**SOLICITATION ADDENDUM NO. 2**

**ITB 20-0032**

**West Tualatin View Elementary Sewer Replacement**

Beaverton School District  
West TV Sewer Replacement  
Addendum  
April 9, 2021

1 PLUMBING PLAN - BASEMENT AREA E  
1/8" = 1'-0"

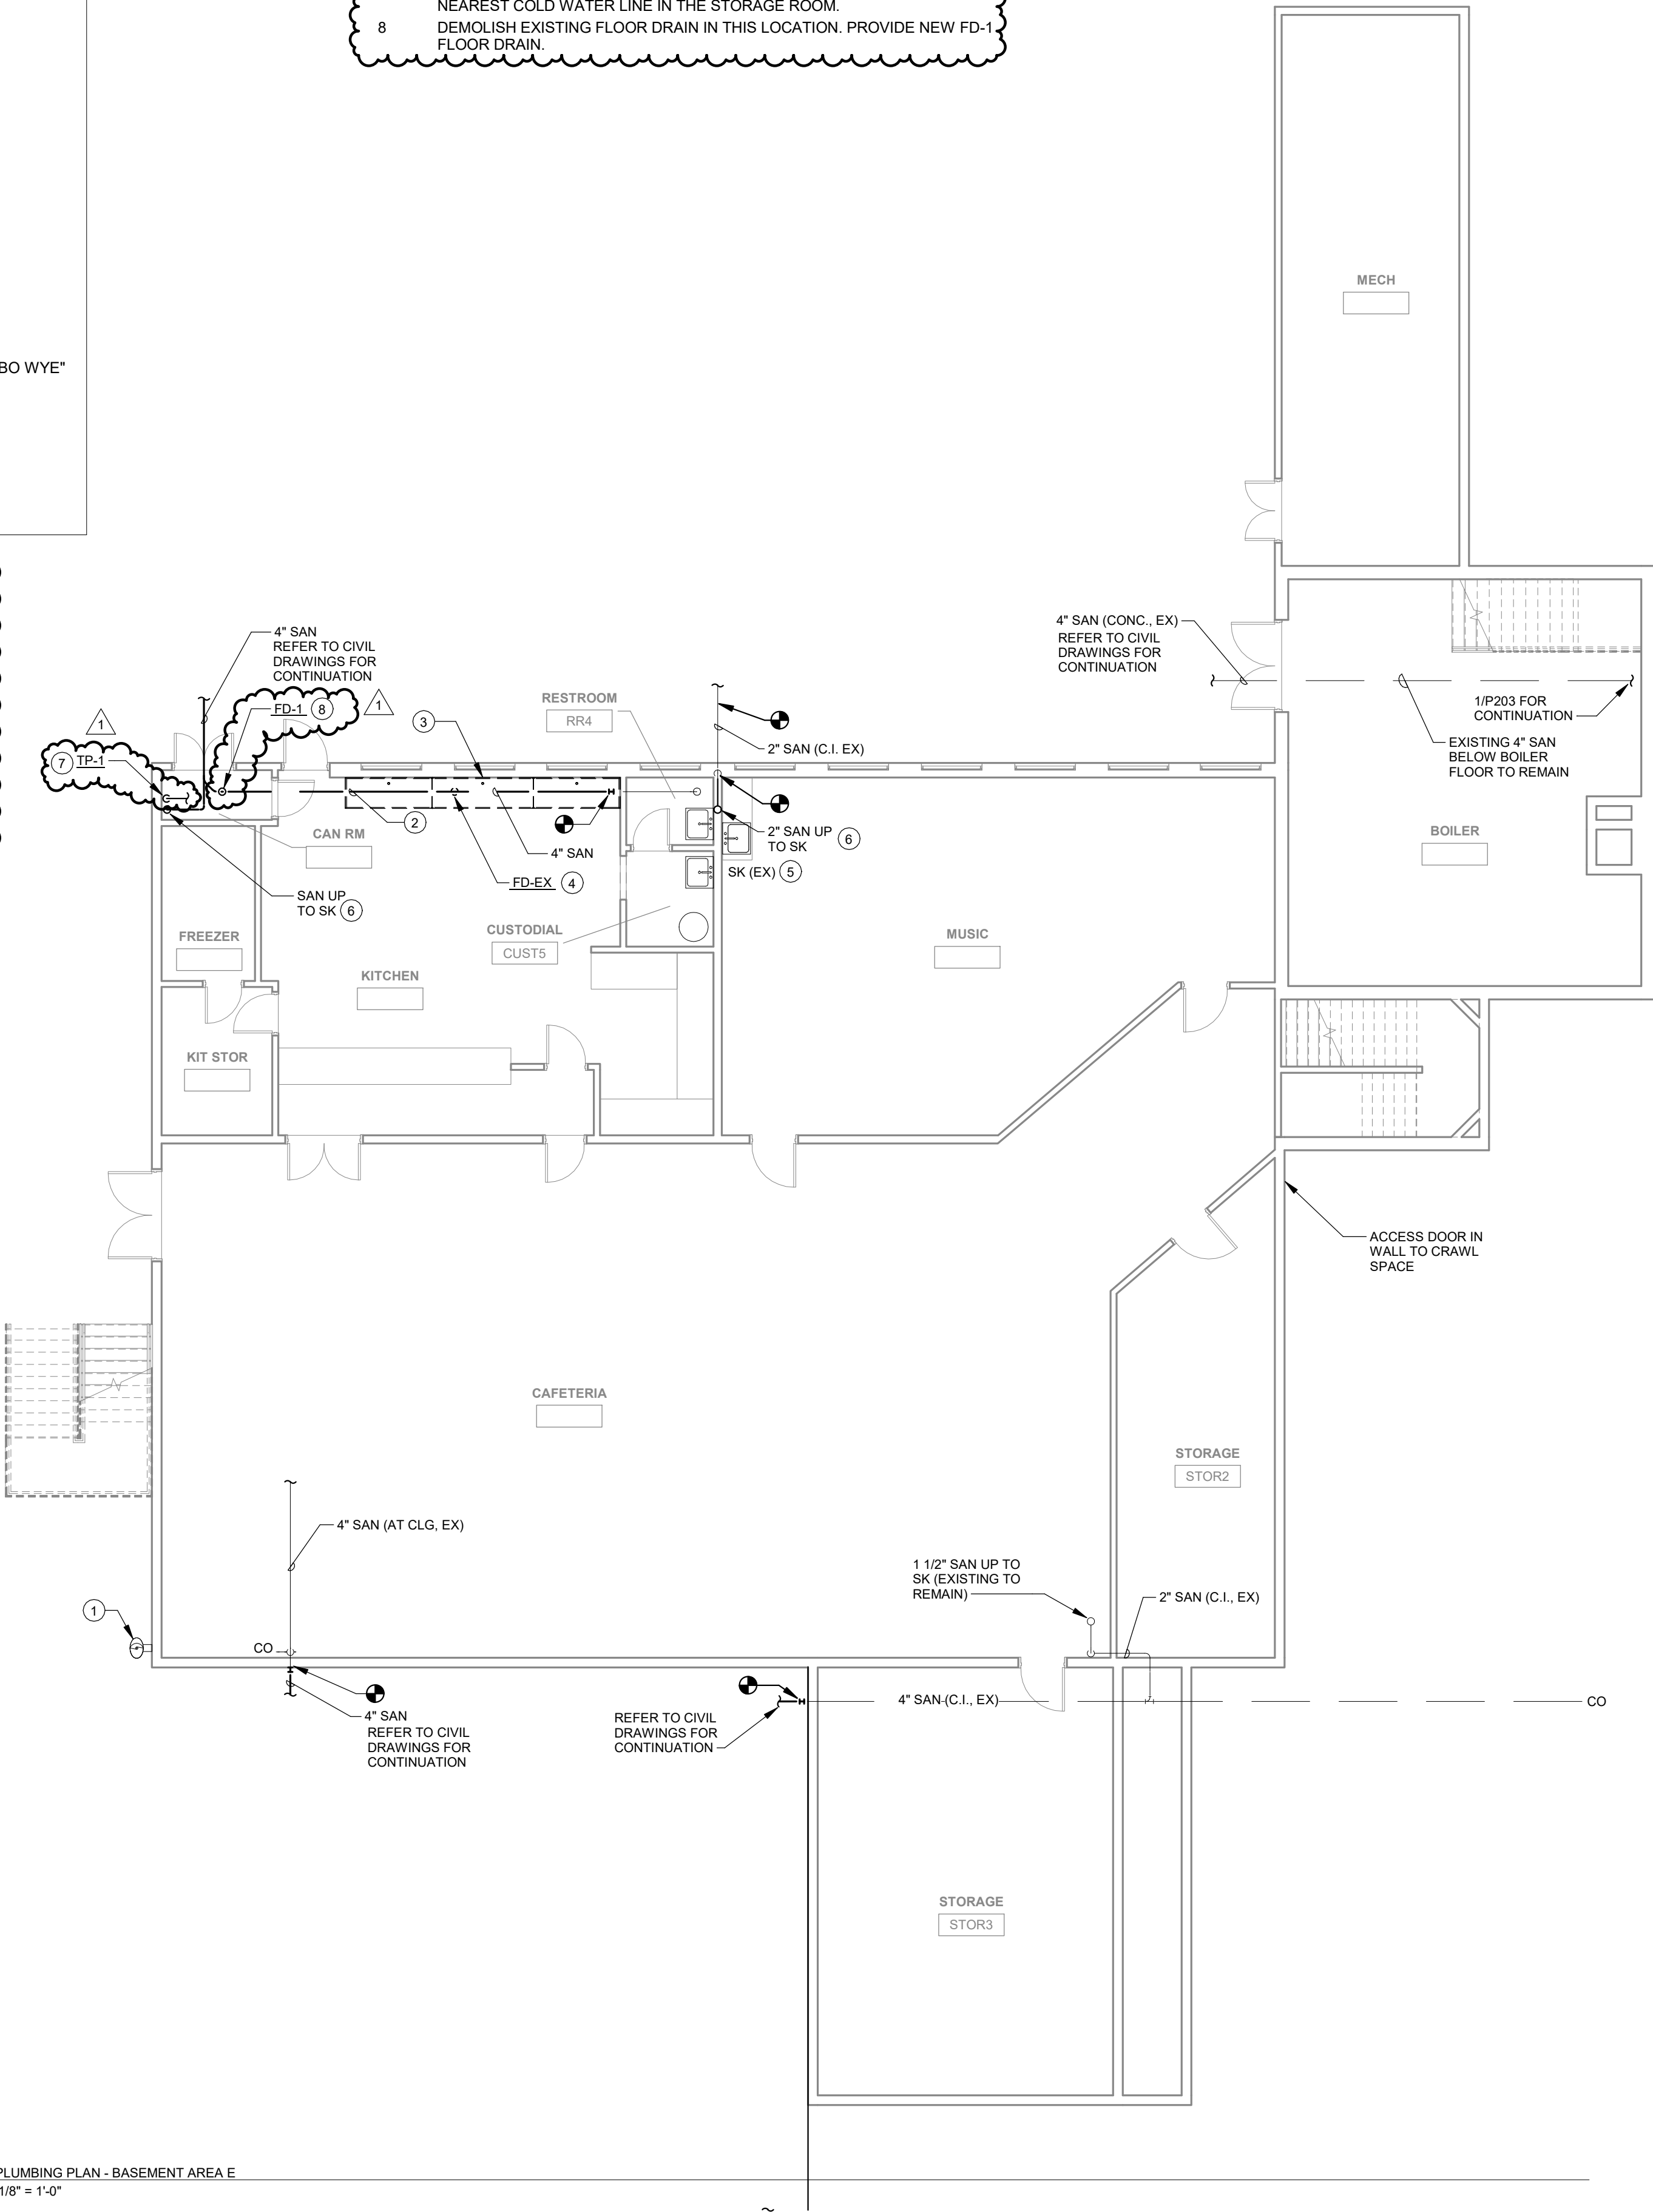
1. Drawing P201 – PLUMBING PLAN – BASEMENT AREA E
  - a. **ADD** floor drain FD-1 and trap primer TP-1 in the CAN RM adjacent to the kitchen.
  - b. **DELETE** the reference to keynote 4 in the CAN RM.
  - c. **ADD** the plumbing fixture schedule with FD-1 and TP-1 requirements.
  - d. **ADD** keynote 7 to read, “INSTALL TRAP PRIMER AT LEAST 12” ABOVE FINISH FLOOR. CONNECT TO NEAREST COLD WATER LINE IN THE STORAGE ROOM.”
  - e. **ADD** a reference to keynote 7 at the new TP-1 in the CAN RM.
  - f. **ADD** keynote 8 to read, “DEMOLISH EXISTING FLOOR DRAIN IN THIS LOCATION. PROVIDE NEW FD-1 FLOOR DRAIN.”
  - g. **ADD** a reference to keynote 8 at the new FD-1 in the CAN RM.
  - h. Refer to attached revised drawing P201.
